Change in specification for terminal block

We would like to inform that we will change the label for terminal block of below products.

Types (e.g.)	Before	After
<p>Electrical operating device(NFM) (Motor-drive type(2))</p>  <p>External view Internal view</p>	 <p>Corporate logo label</p> <p>Side view of terminal block</p>	 <p>Side view of terminal block</p>

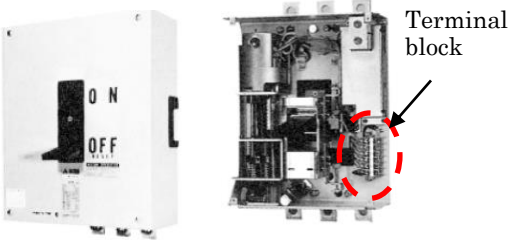
To remove the corporate logo label.

There is no change in product characteristics by this specification change.
